Subject: Davis-Besse Nuclear Power Station
License Amendment Application to Revise Technical Specification Requirements for
Refueling Operations and Design Features to Reflect the Status of the Spent Fuel
Pool Rerack Project (License Amendment Request No. 02-0003)

**DAVIS-BESSE NUCLEAR POWER STATION
EVALUATION
FOR
LICENSE AMENDMENT REQUEST NUMBER 02-0003**

**PROPOSED MARK-UP
OF
TECHNICAL SPECIFICATION PAGES**

Figure 3.9-1
 Burnup vs. Enrichment Curves
 For the Davis-Besse Low Density
 Spent Fuel Pool Storage Racks

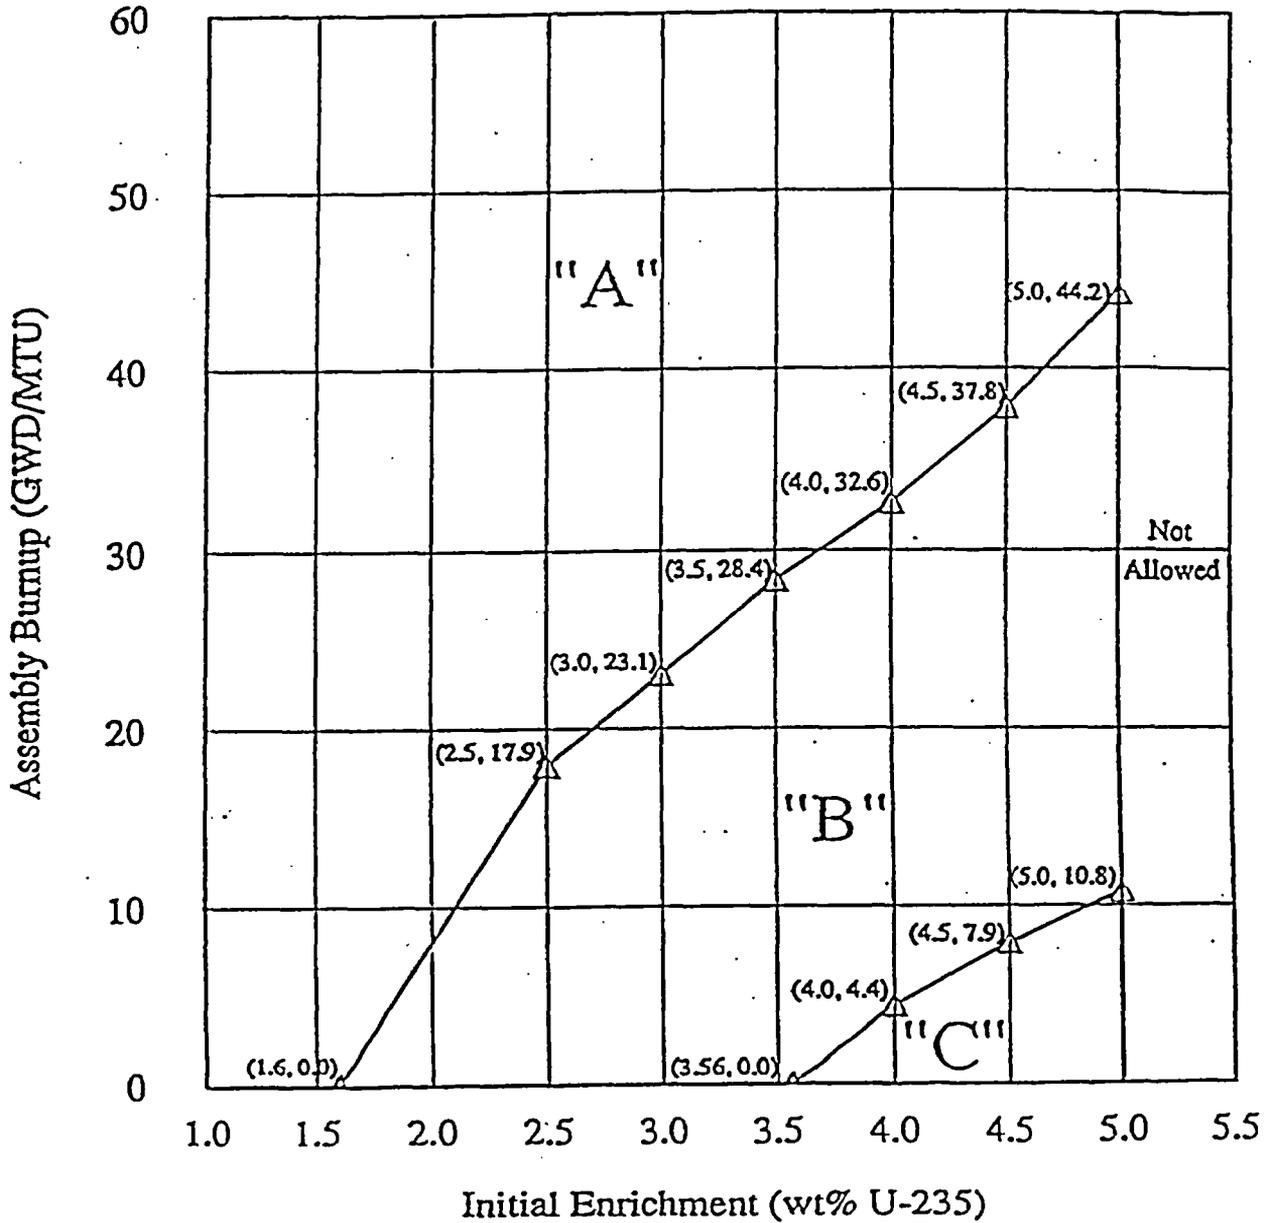
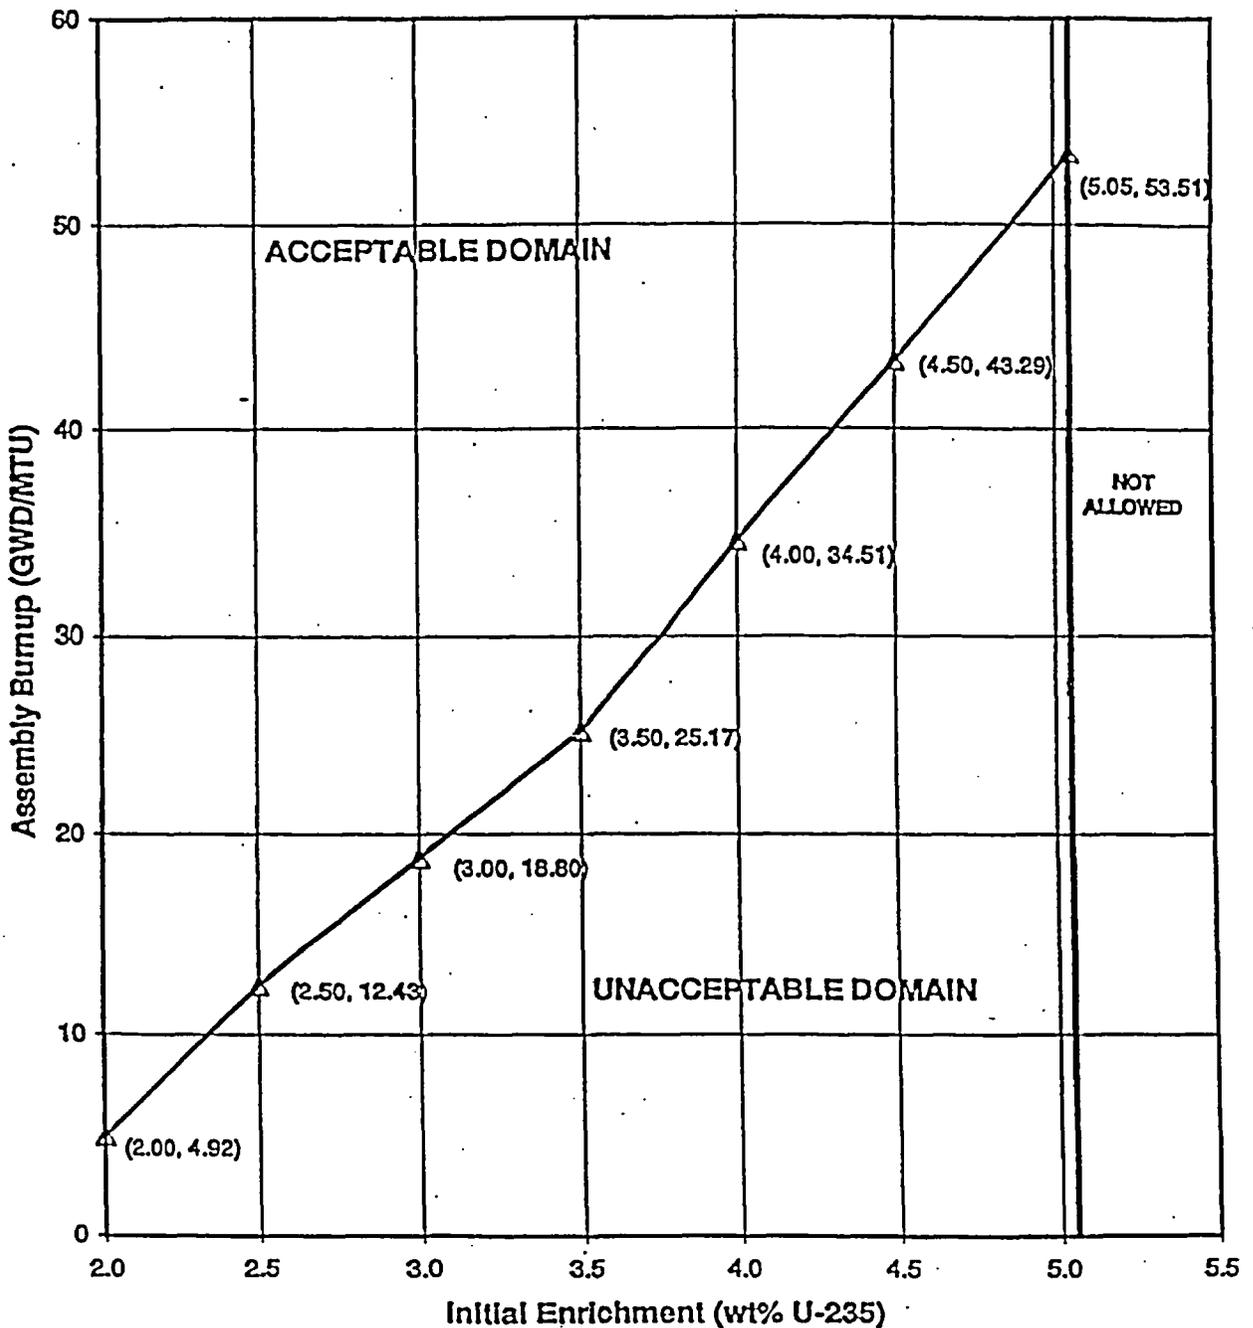
The proposed change would delete TS Figure 3.9-1, "Burnup vs. Enrichment Curves for the Davis-Besse Low Density Spent Fuel Pool Storage Racks," and TS Figure 3.9-2, "Burnup vs. Enrichment Curve for the Davis-Besse High Density Cask Pit Storage Racks." Existing TS Figure 3.9-3, "Burnup vs. Enrichment Curves for the Davis-Besse High Density Spent Fuel Pool and Transfer Pit Storage Racks," would be renumbered and renamed Figure 3.9-1, "Burnup vs. Enrichment Curves for the Davis-Besse High Density Spent Fuel Pool Storage Racks."

- a. ~~Fuel assemblies stored in the spent fuel pool shall be placed in the spent fuel storage racks meet the criteria shown in accordance with the criteria shown in Figure 3.9-1, when located in the low density spent fuel storage racks.~~
- b. ~~Fuel assemblies stored in the cask pit shall meet the criteria shown in Figure 3.9-2, when located in the high density spent fuel storage racks.~~
- c. ~~Fuel assemblies stored in the spent fuel pool or transfer pit shall meet the criteria shown in Figure 3.9-3, when located in the high density spent fuel storage racks.~~

Fuel assemblies stored in the spent fuel pool shall be placed in the spent fuel storage racks in accordance with the criteria shown in Figure 3.9-1.
